## Relevant Information for Central Sydney Planning Committee

**FILE:** D/2018/405 **DATE:** 5 December 2018

**SUBJECT:** Information Relevant To Item 4 – Development Application: 378-394 George Street, Sydney

**Figure 1 Floor Space Ratio Summary**

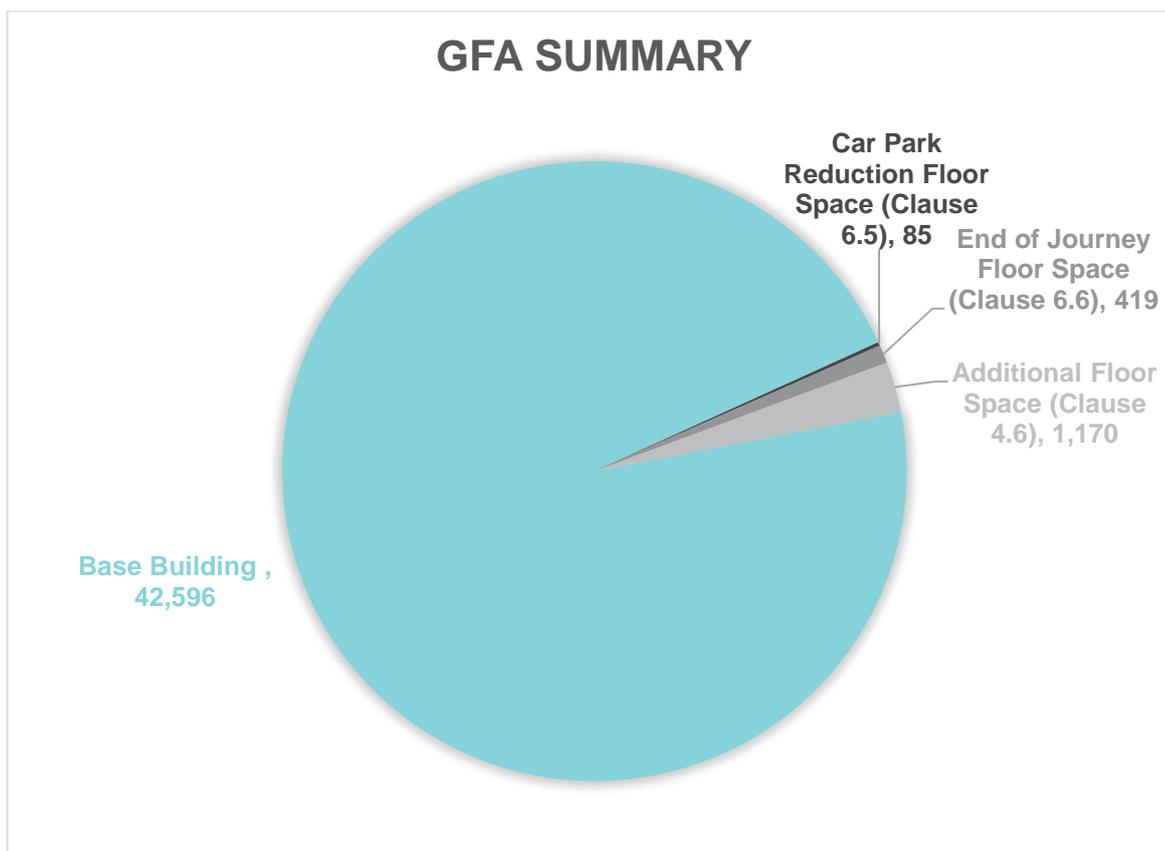
It is well established in case law that the extent of the numerical variation does not form part of the test required to be exercised under Clause 4.6. Decisions in respect of *Micaul Holdings P/L v Randwick City Council* (55% exceedance of height and 20% exceedance of FSR) and *Moskovich v Waverley Council* (65% exceedance of FSR) support this.

The applicant says the proposal only increases the gross floor area by 1,382m<sup>2</sup> or 3.24%. The applicant then attempts to relate this floor space ratio to a covenant which relates to the site but has no bearing or relevance to the Sydney Local Environmental Plan 2012. The gross floor area of the proposal in fact exceeds not only the base FSR (8:1) and accommodation FSR bonus (4.5:1) which provide a maximum of 12.5:1. The applicant then seeks to claim a car parking reduction floor space under Clause 6.5 replacing 3 car spaces with a lift shaft (which does not generate a GFA requirement) and then attempts to relocate this space in the new building. This is not available to the applicant under Clause 6.5

**Figure 2 Historic Development at the site**

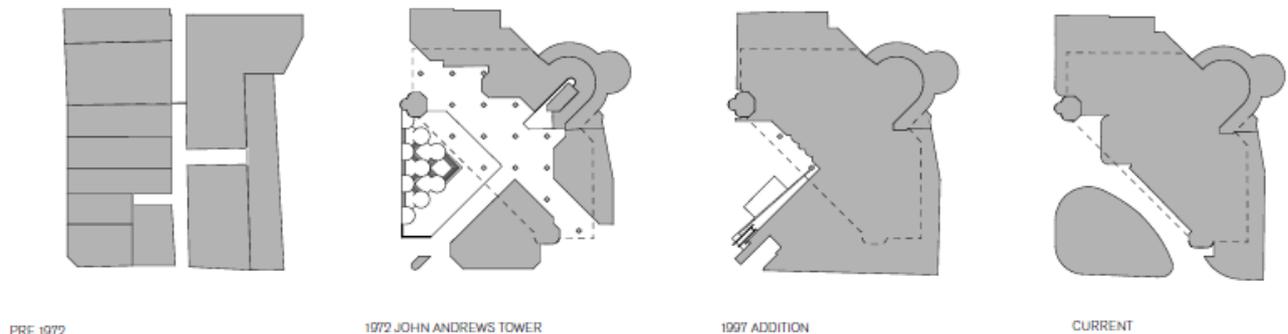
**Figure 2** below illustrates that, historically, the built form of this intersection has provided both definition to the street corner and finer grain opportunities for pedestrian movement through laneways or through-site-links. Both these features were removed as part of the 1997 addition works, which removed the through-site-link and also, in creating the entrance plaza on George Street, destroyed the definition of the street alignment in this location.

**Figure 3** Relationship between proposed development and adjoining 'Blackett' building

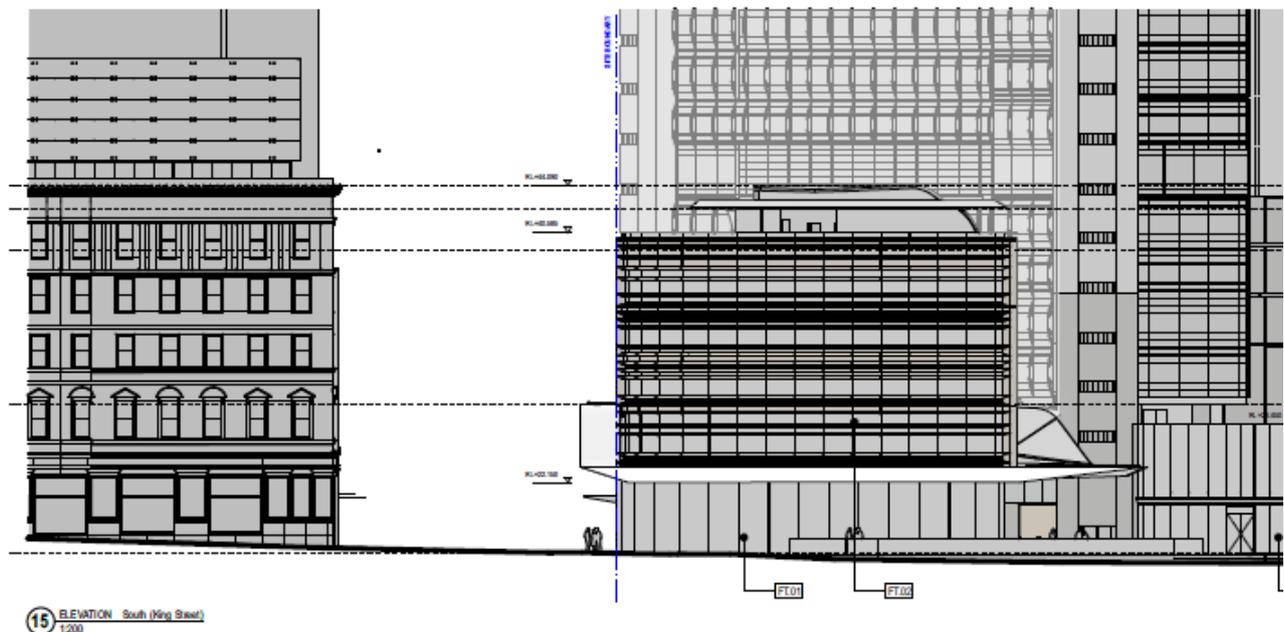
The current building form on the site, which is not built to its boundary, does not appropriately address the corner of King Street and George Street, one of the most significant intersections in the Sydney CBD. Currently, when walking south along George Street, the existing plaza severs the through site link that was originally provided by

Andrews' design. The extent of ground coverage and building height of this existing corner building is inconsistent with the building scale presented by the neighbouring buildings on the three adjacent corners of this intersection. Specifically (as shown in **Figure 3**) the proposed development would deliver a building form that appropriately responds to the heritage-listed 'Blackett' (Louis Vuitton) building, which is located to the west of the site on the opposite side of George Street. The proposed development would also provide a more appropriate response to the existing building form on the southern side of King Street, where the existing buildings are built to their respective boundaries and help to define the corner of the intersection and provide activated frontages to the pedestrian footpath.
